# **STATEMENT OF BASIS CORRECTIVE MEASURES SELECTION**

Bethlehem Steel (Tecumseh Redevelopment, Inc.)  
OU-06 Former Petroleum Bulk Storage Sub-Area  
OU-07 Coal, Coke and Ore Handling and Storage Sub-Area,  
and Coke Plant and By-Products Facility Sub-Area

Site No. 915009

This responsiveness summary responds to all questions and comments raised during the public comment period. The following are the comments received, with the Department's responses:

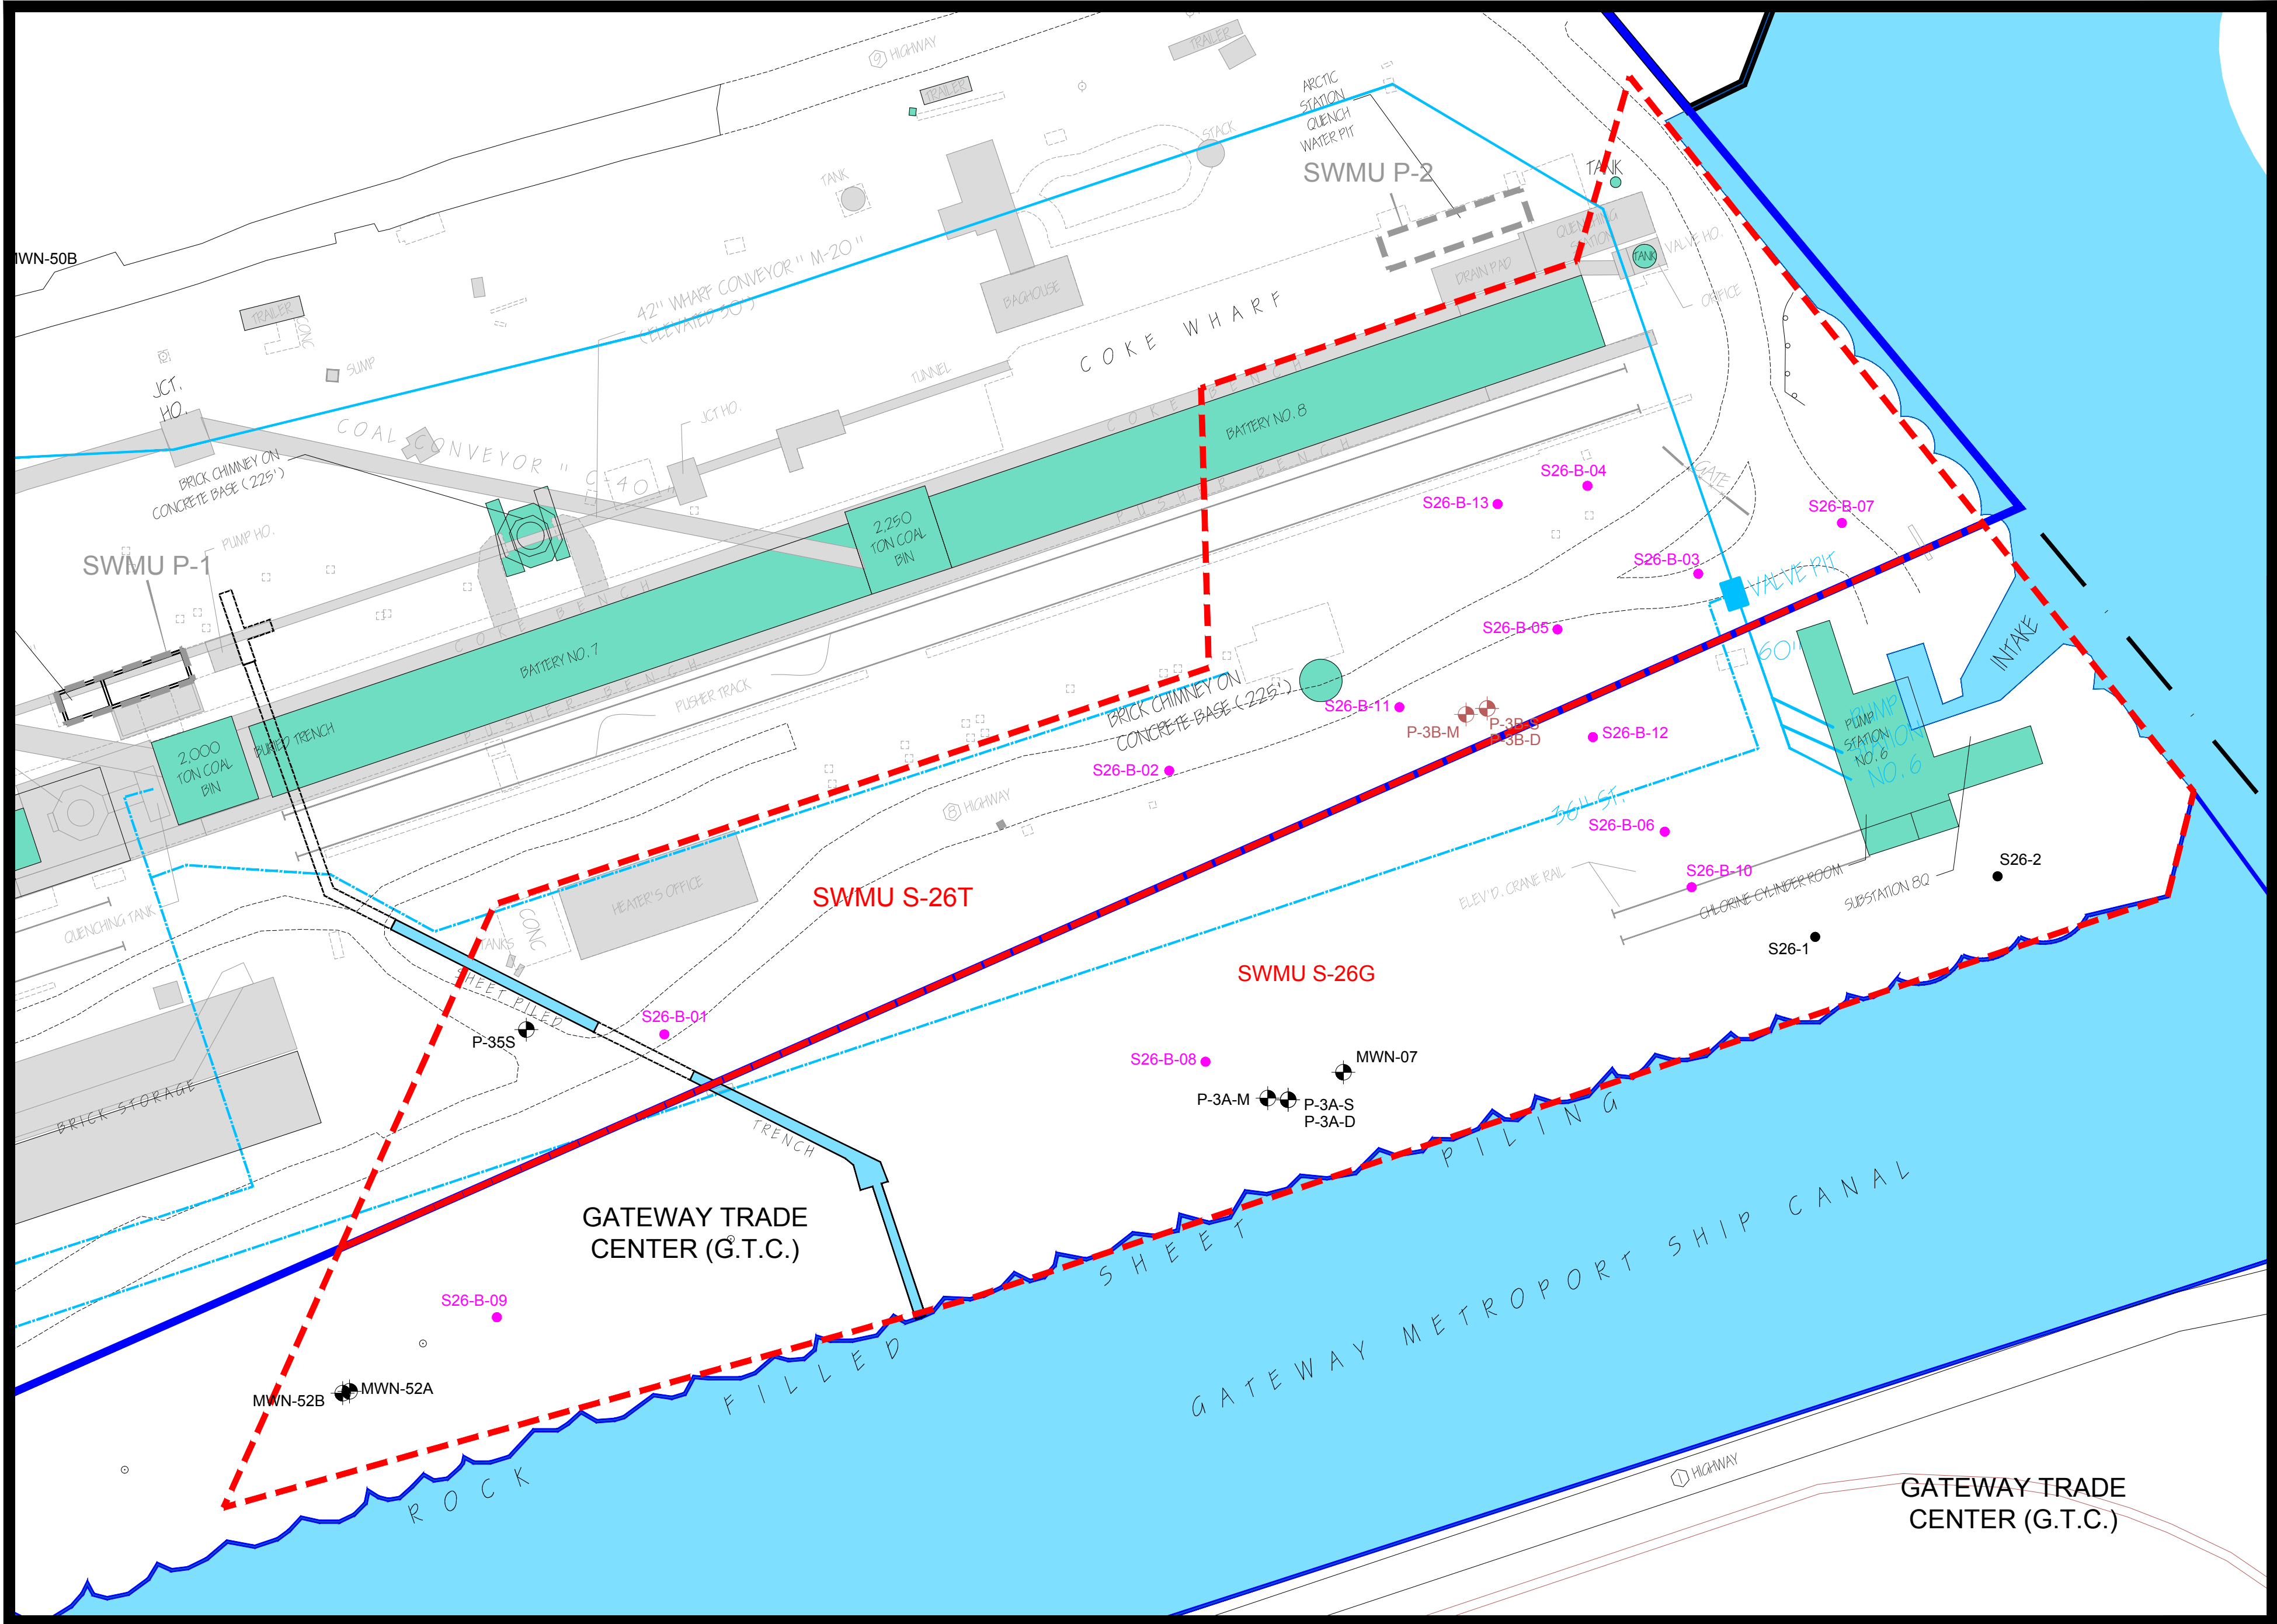
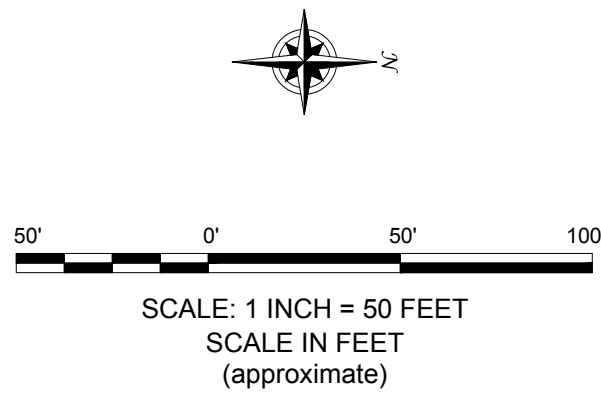
**Comment 25:** SWMU S-26 is an approximately 7.5-acre area located adjacent to and northwest of the Canal generally occupying the area between former Coke Oven Battery Nos. 7 and 8 and the Canal. The Unit is split between two properties: approximately 3.3 acres (SWMU S-26 T) on the Tecumseh Site and 4.2 acres (SWMU S-26G) on the adjacent Gateway property as shown on Figure 1 with boring and monitoring well locations. Gateway purchased this portion of the property in 1985 from Bethlehem Steel along with the Canal. As such, Tecumseh never owned or contributed to the contamination existing on Gateway's property (i.e., SWMU S-26G). See Exhibit A, Legal Background and Tecumseh's Position Regarding Liability for Off-Site Contamination, for detailed discussion of Tecumseh's position with respect to SWMU S-26G.
